RESPONSE TO REQUEST FOR ADDITIONAL INFORMATION

APR1400 Design Certification

Docket No. 52-046

RAI No.:	**416-8358**
SRP Section:	**SRP 19**
Application Section:	**19.1**
Date of RAI Issued:	**02/23/2016**

Figure 19.1-27 Level 1 Event Tree - Loss of Instrument Air (LOIA)

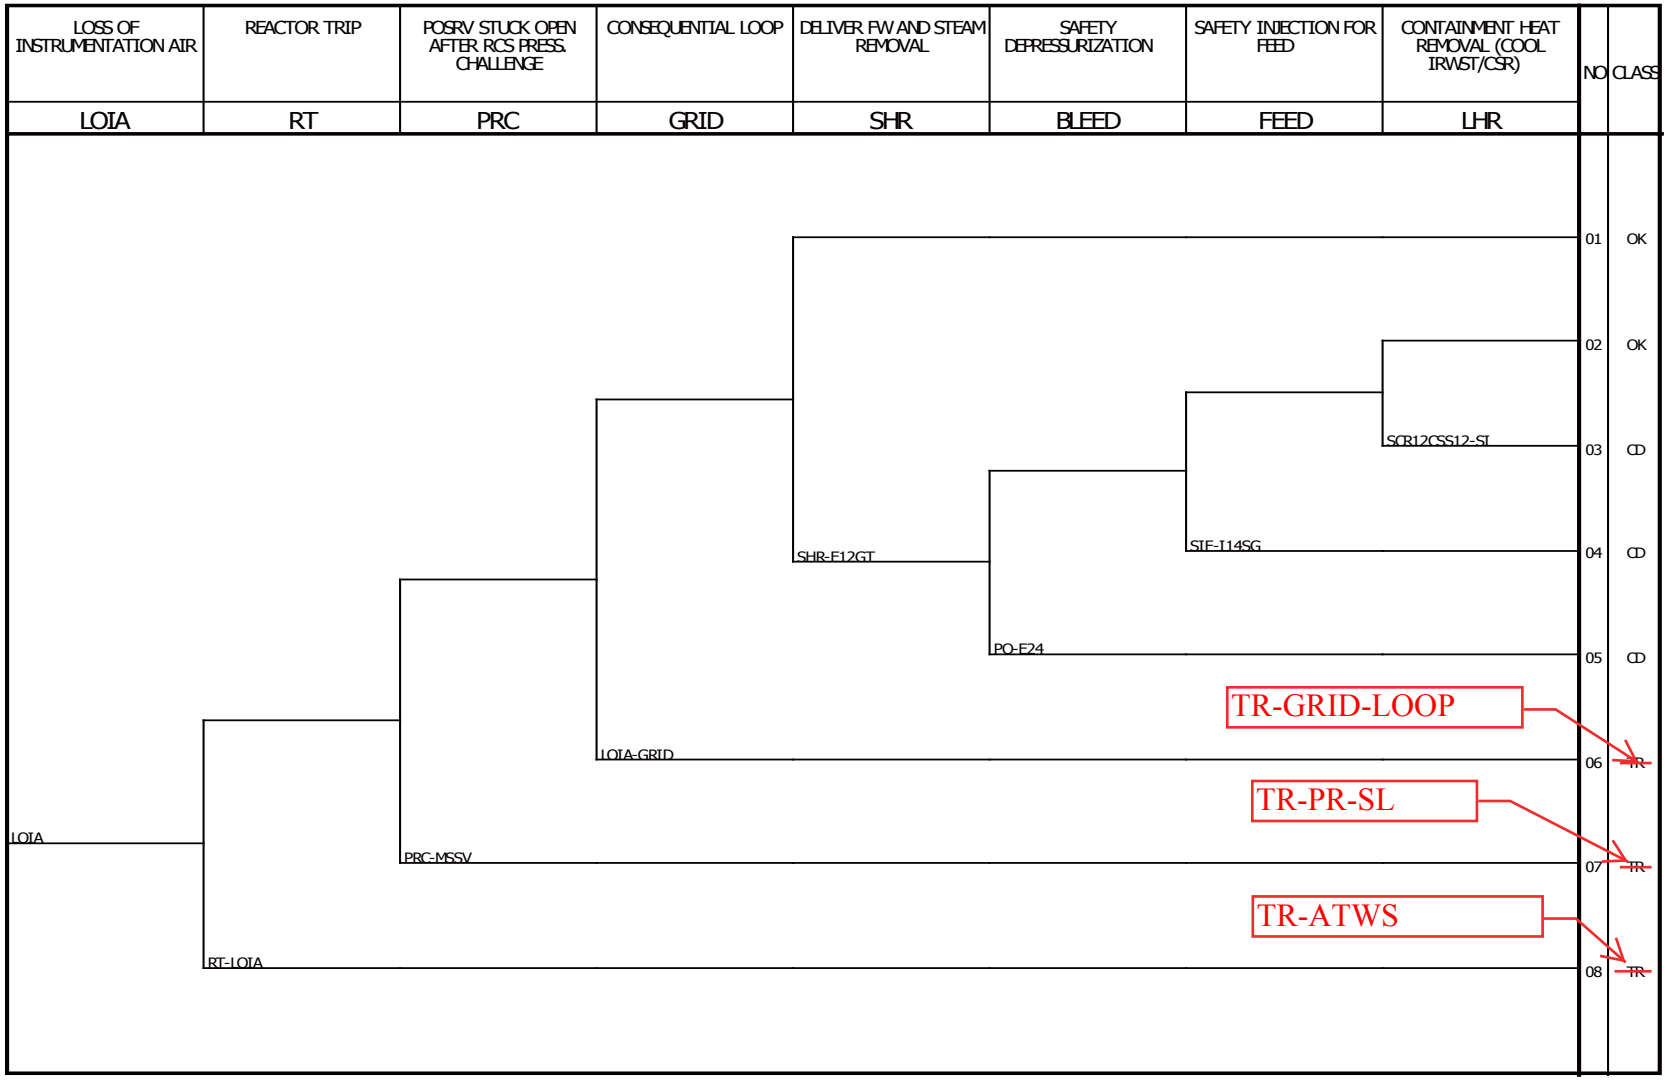
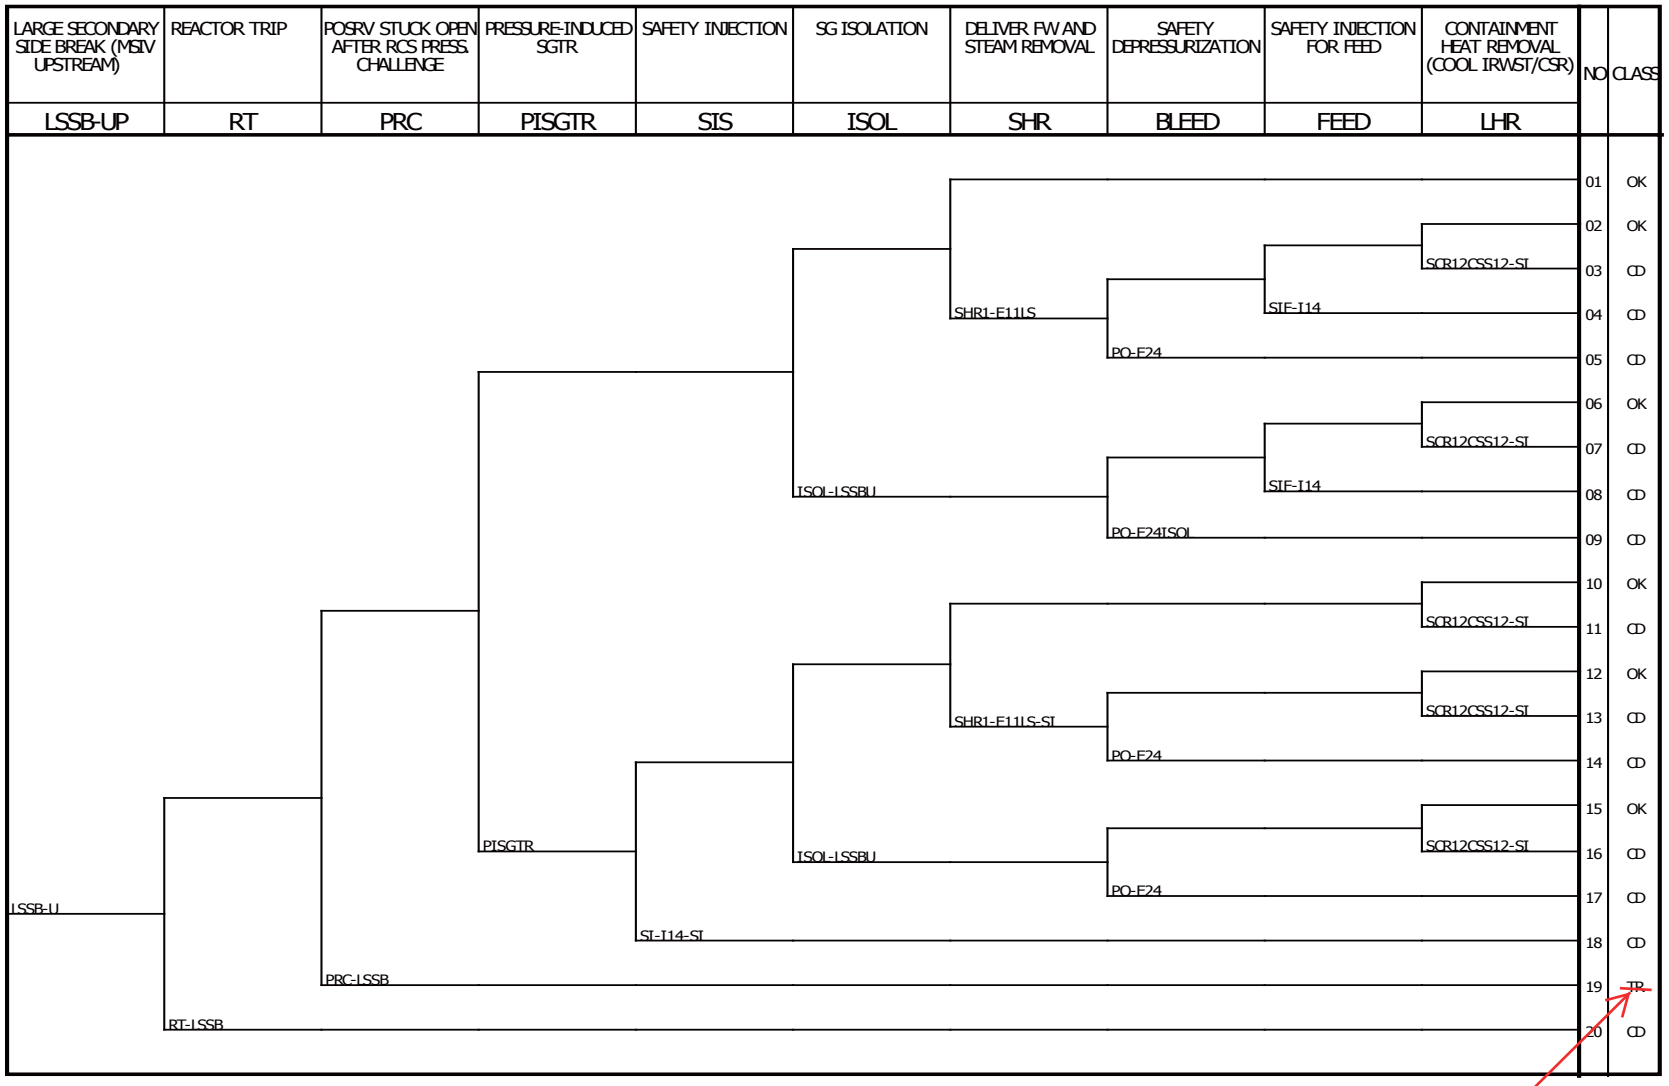
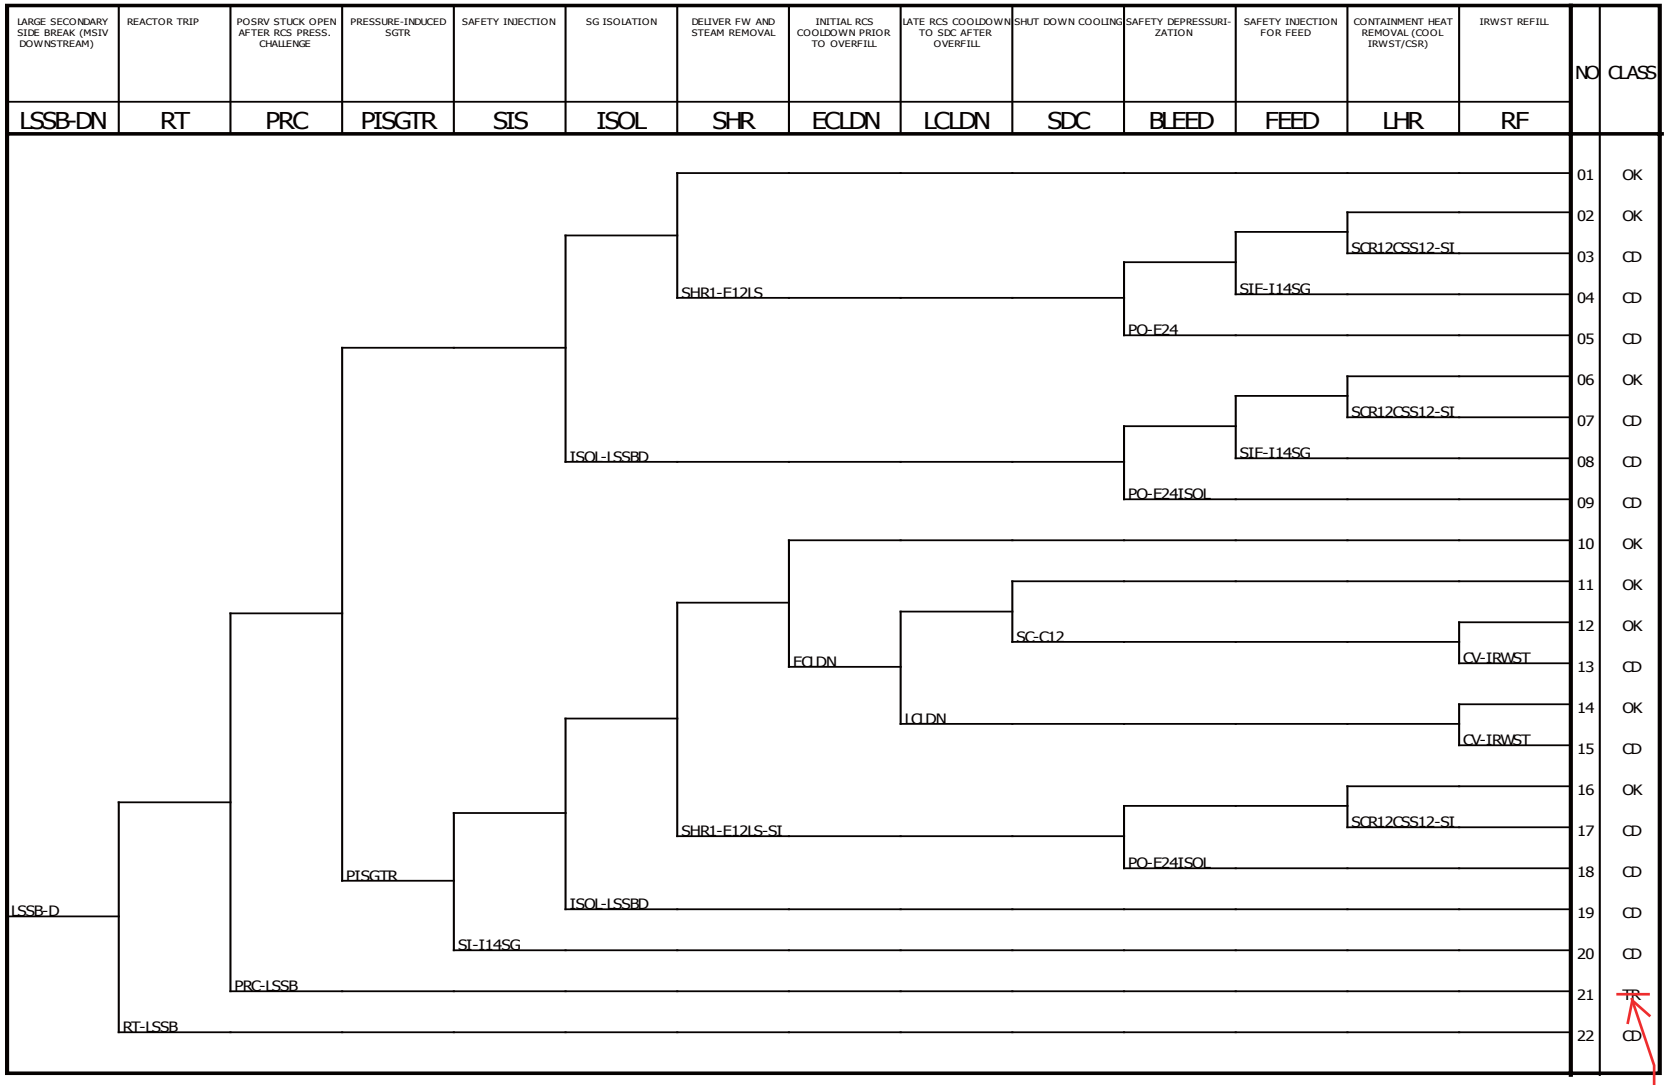
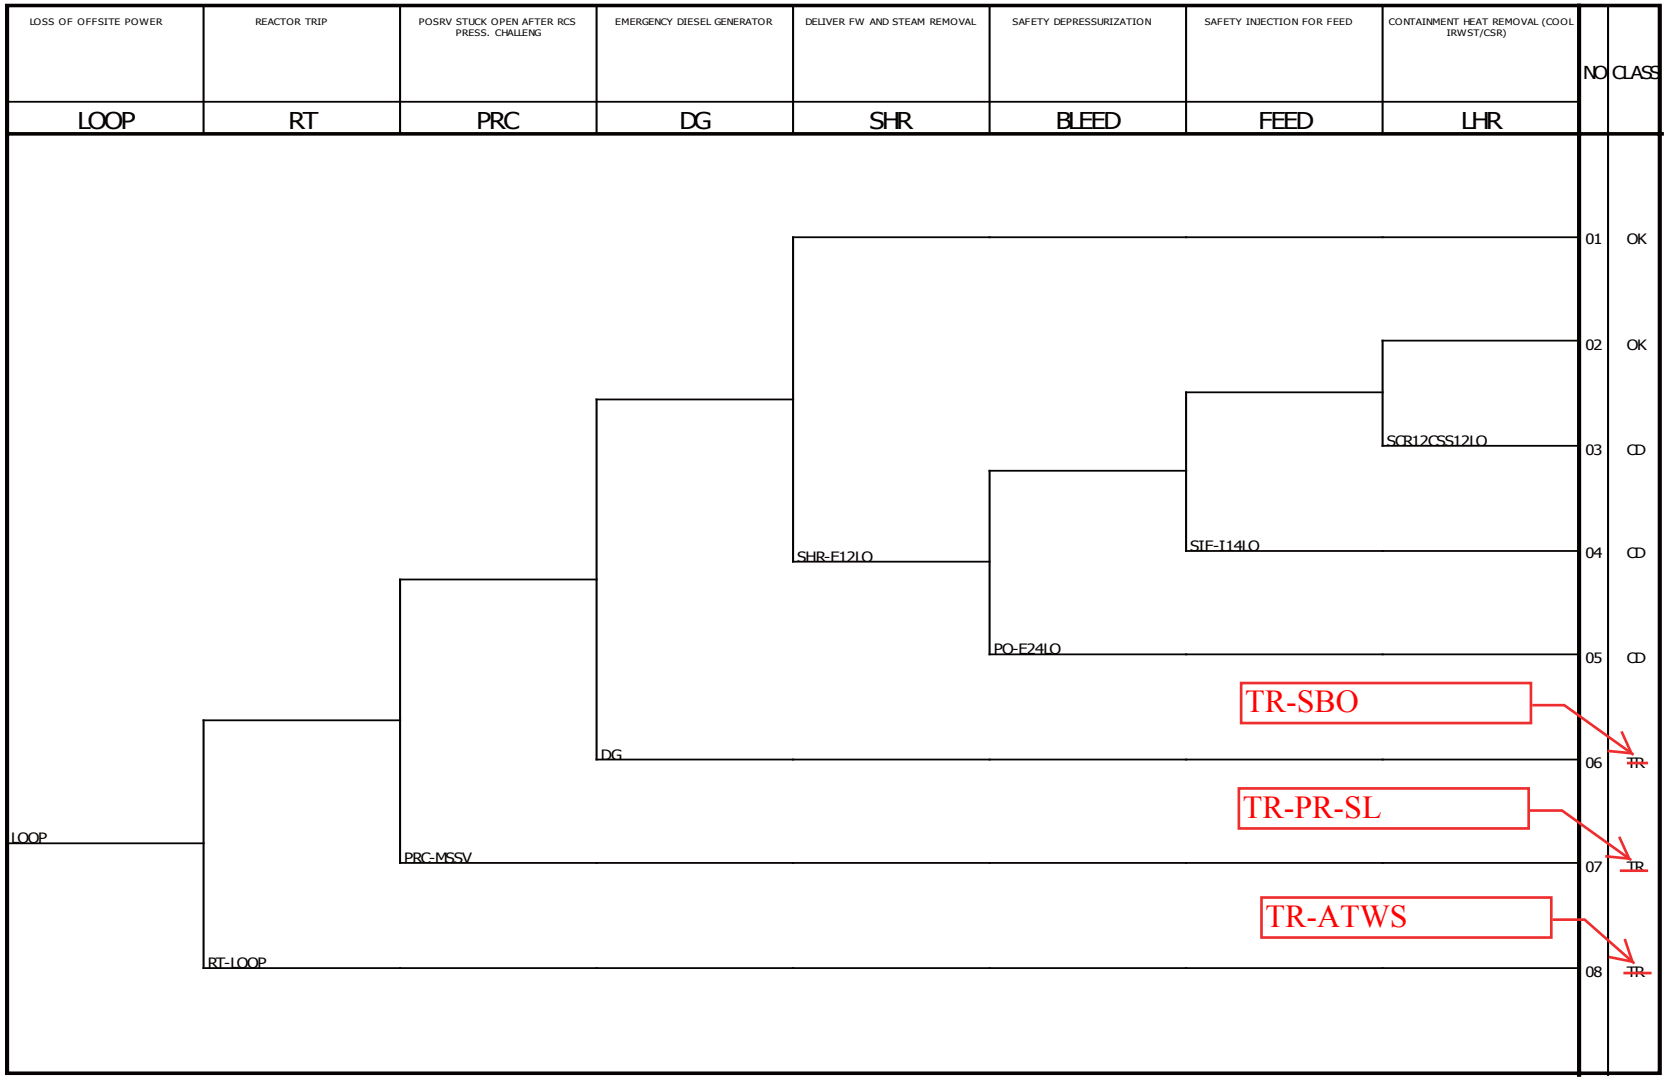
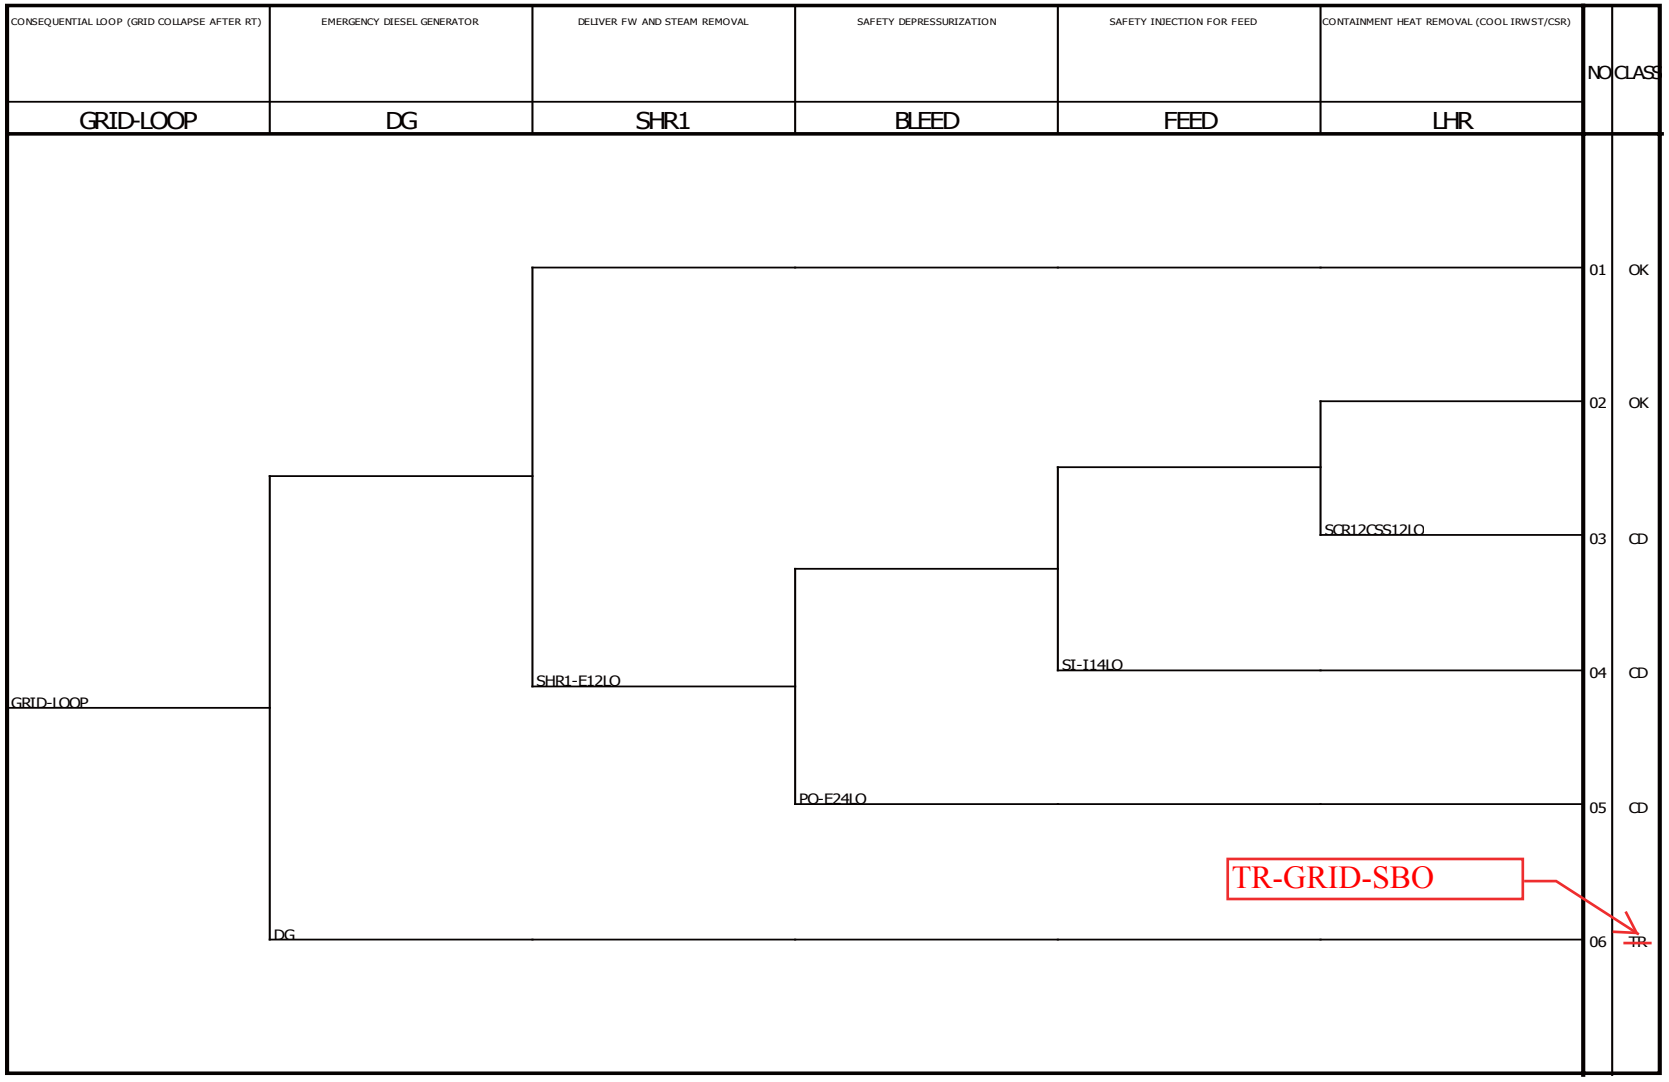
2 The transfers shown in the event trees to not identify the trees they transfer to

2. The pictures of the event trees provided in the DCD with transfer sequences will be revised to identify the event tree to which it is being transferred. Attachment 2 contains the revised event tree pictures.

The revised pictures include an identifier to indicate to which event tree the sequence is transferred. Obviously, transfer sequences which include failure of reactor trip transfer to the ATWS event tree (TR-ATWS), transfer sequences which include stuck open POSRVs transfer to the stuck-open POSRV event tree (TR-PR-SL), transfer sequences with include consequential LOOP transfer to the consequential LOOP event tree (TR-GRID-LOOP), LOOP sequences with failure of all DGs transfer to the SBO event tree (TR-SBO) , and finally GRID-LOOP sequences with failure of all DGs transfer to the GRID-SBO event tree (TR-GRID-SBO).
